ADDENDUM #3
WELL #9 WATER TREATMENT FACILITY - PHASE 1 WELL AND BUILDING
CITY OF MENOMONIE
PROJECT 05323007.1
January 20, 2026

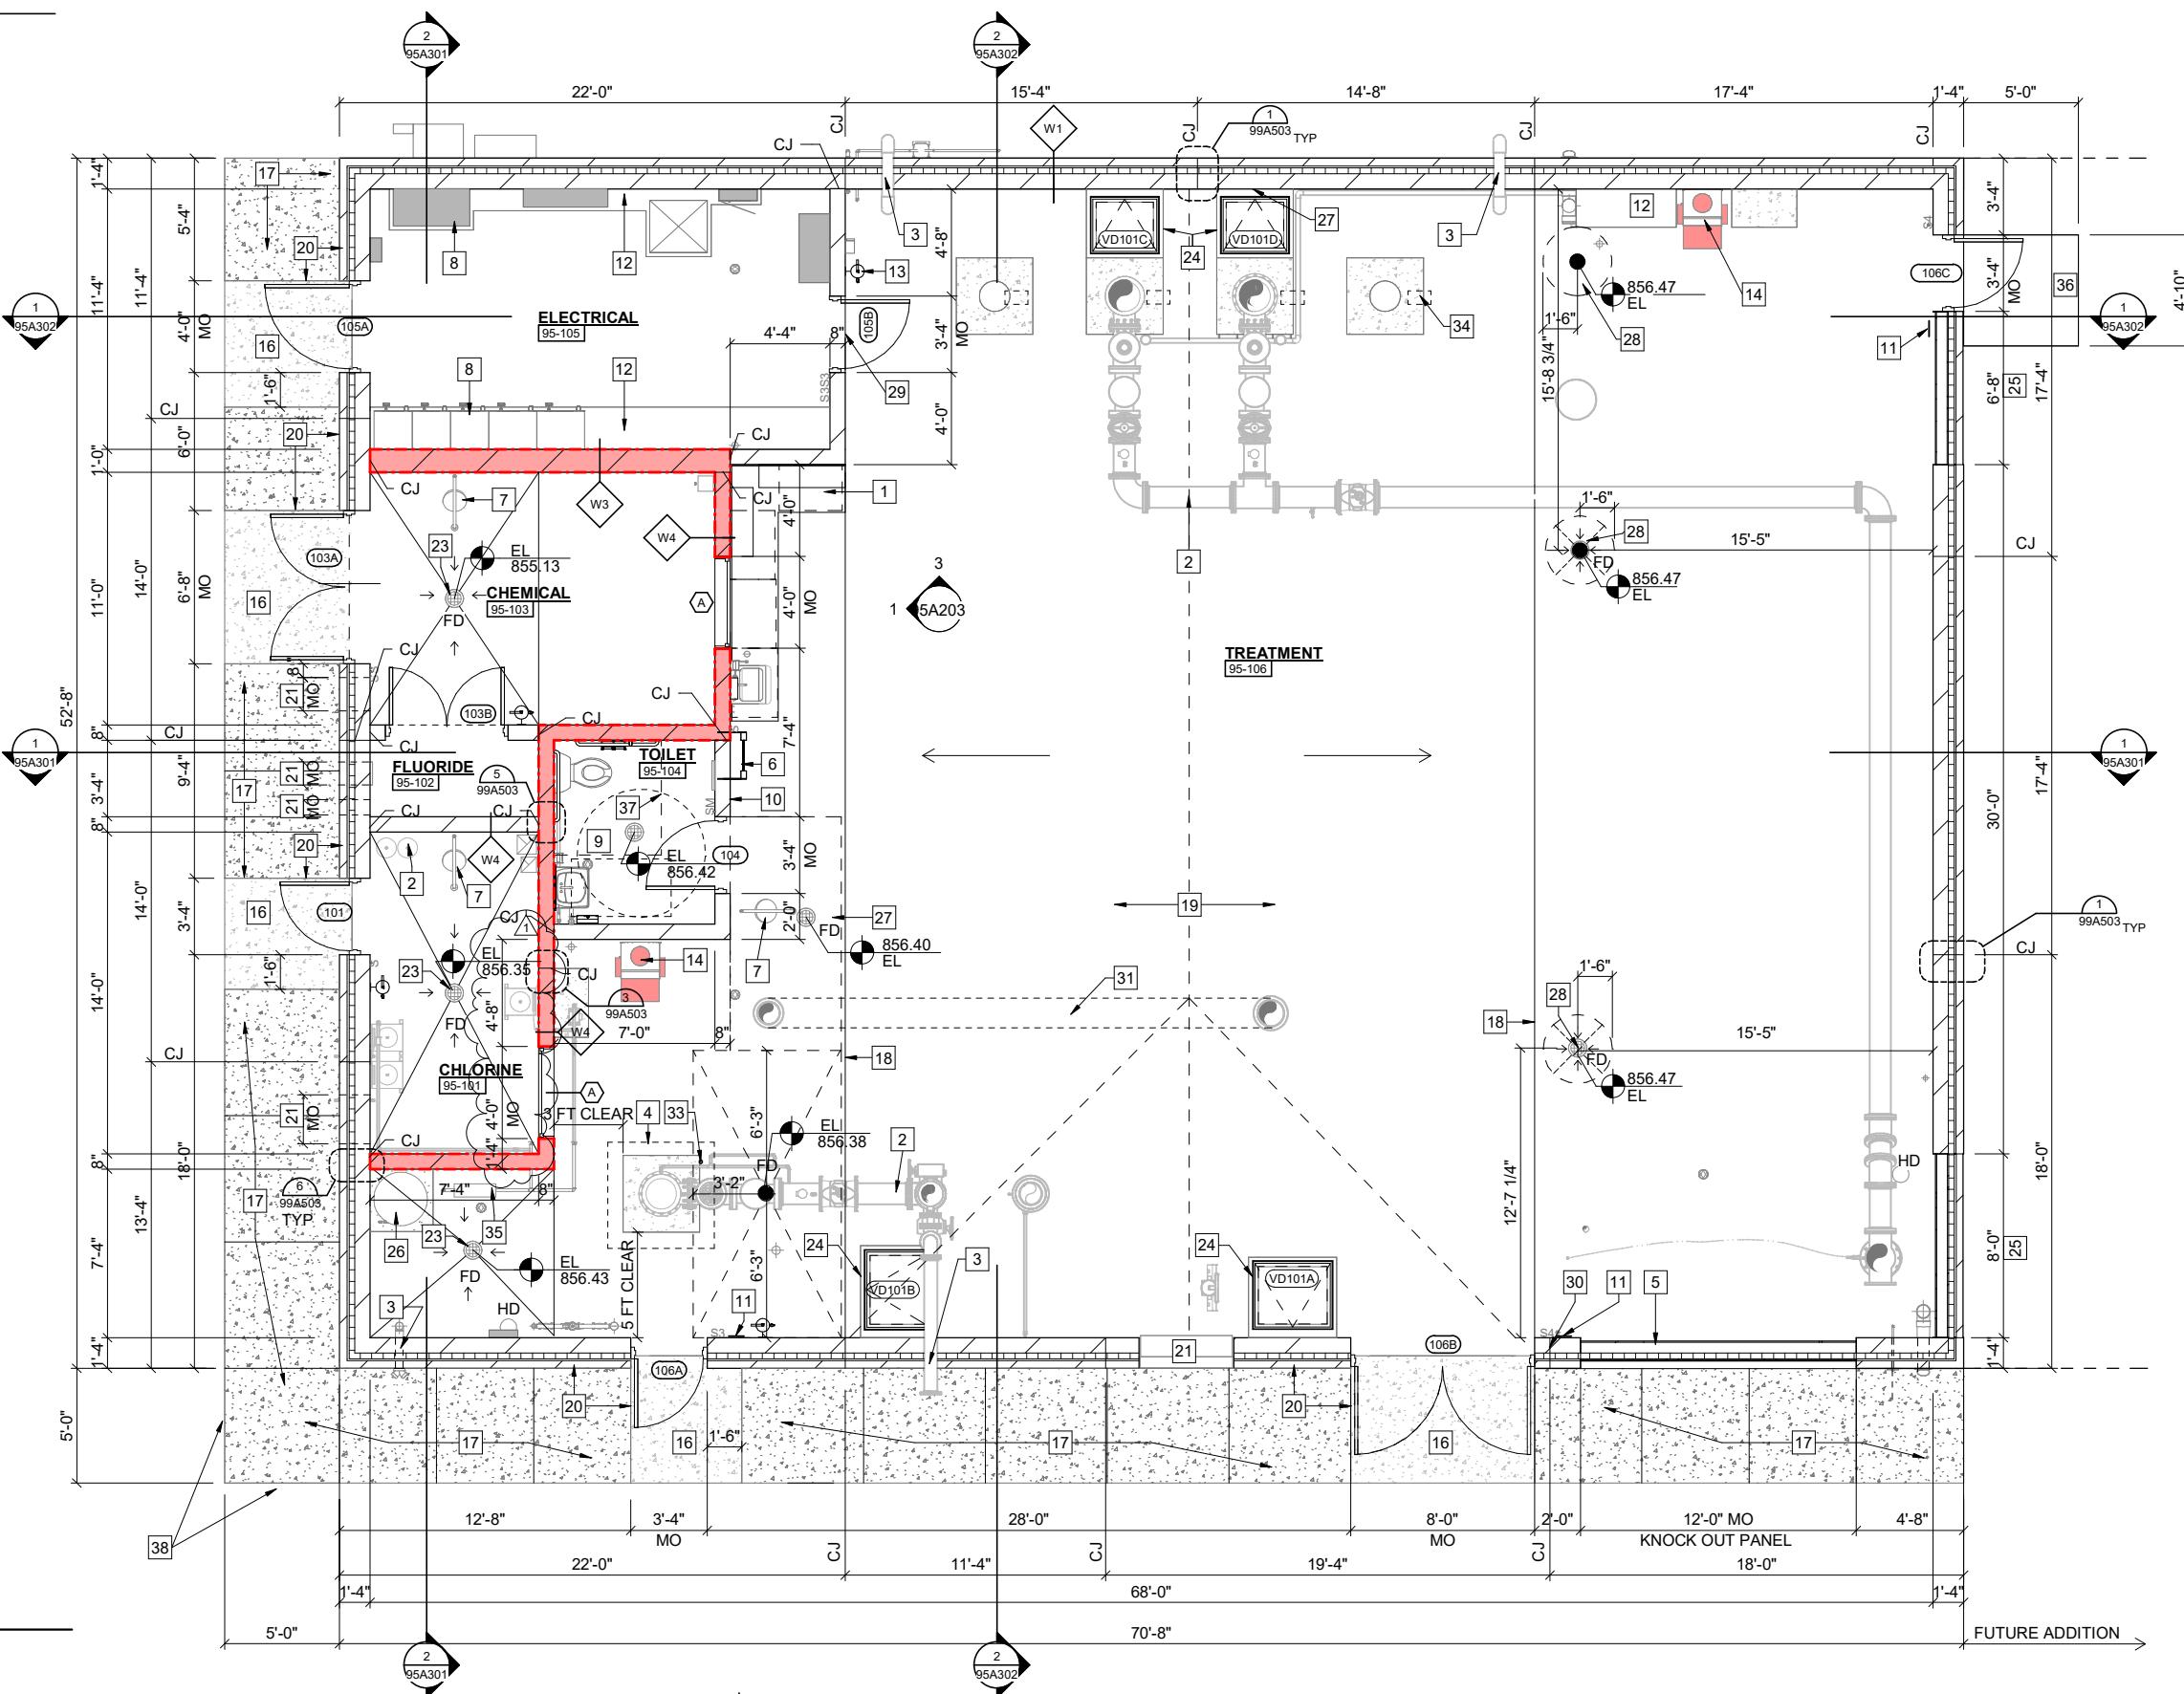
REPLACE Sheet 95A101 in its entirety with the attached sheet marked "Addendum No. 3".
Notes: Clarifying the location of the interior window.

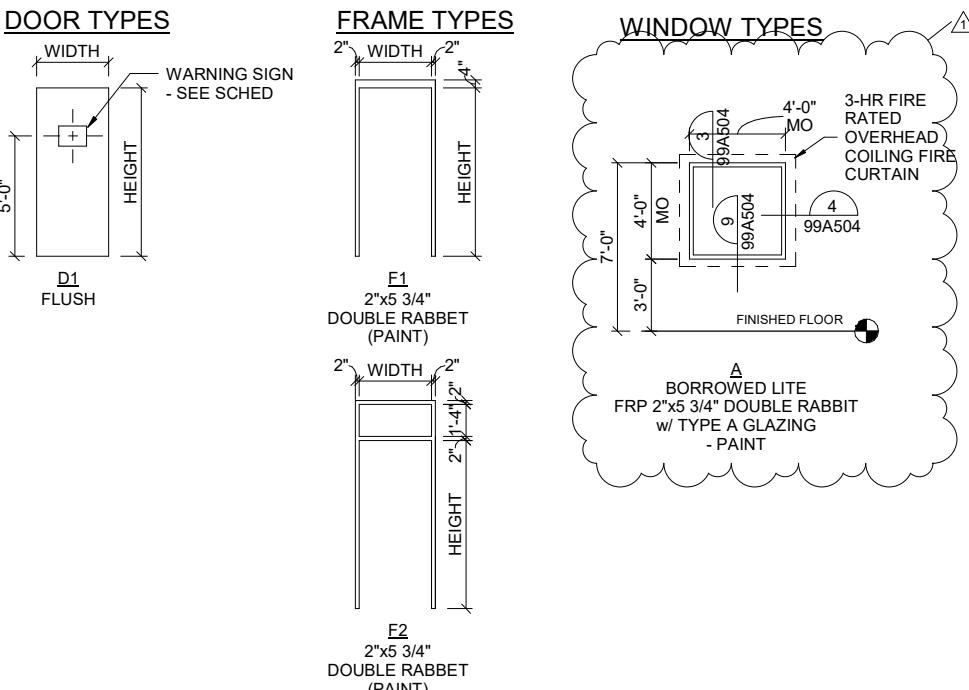
REPLACE Sheet 99A601 in its entirety with the attached sheet marked "Addendum No. 3".
Notes: Providing additional information and clarification of the window legend.
